Additions and Corrections

The following presents additional information and technical errors found between June 15, 2022, and February 18, 2026, in the SI editions of the 2022, 2023, 2024, and 2025 *ASHRAE Handbook* volumes. Occasional typographical errors and nonstandard symbol labels will be corrected in future volumes. The most current list of Handbook additions and corrections is on the ASHRAE website (www.ashrae.org).

Fig. 3 Tiers of BAS
(ASHRAE Guideline 13)
2023 HVAC Applications, Ch. 41, p. 9

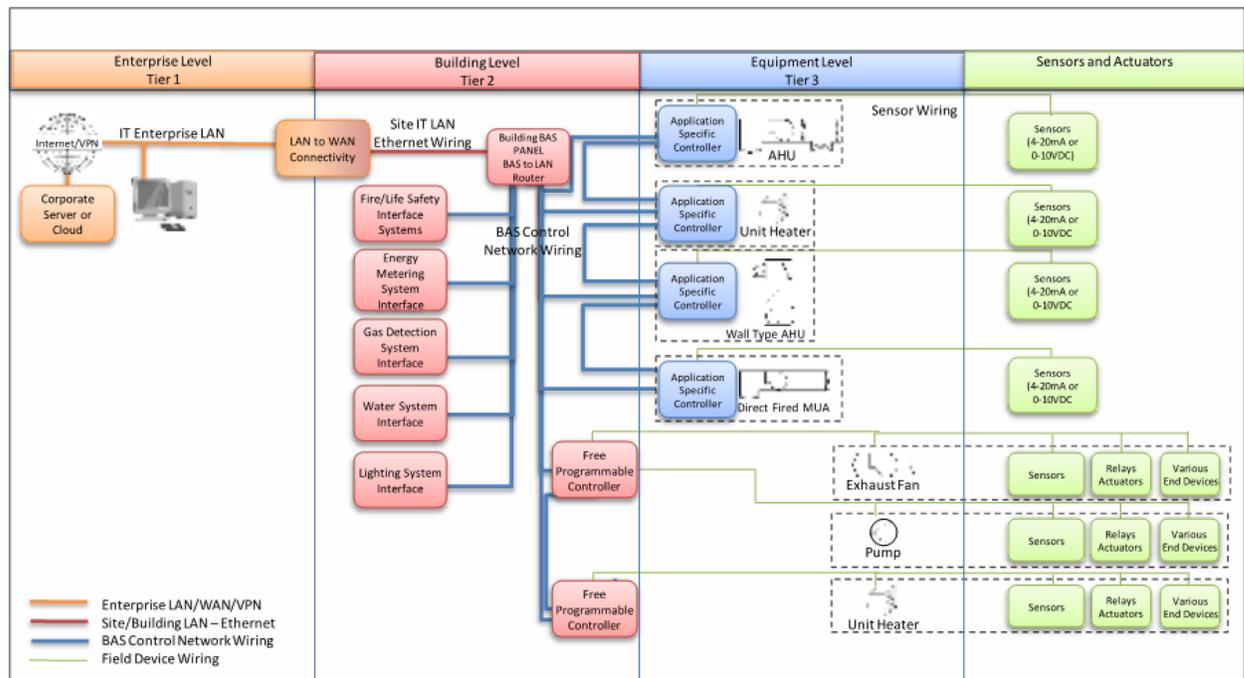
p. 41.9, Figure 3. The bottom of this figure was cut off. The complete version is supplied below.
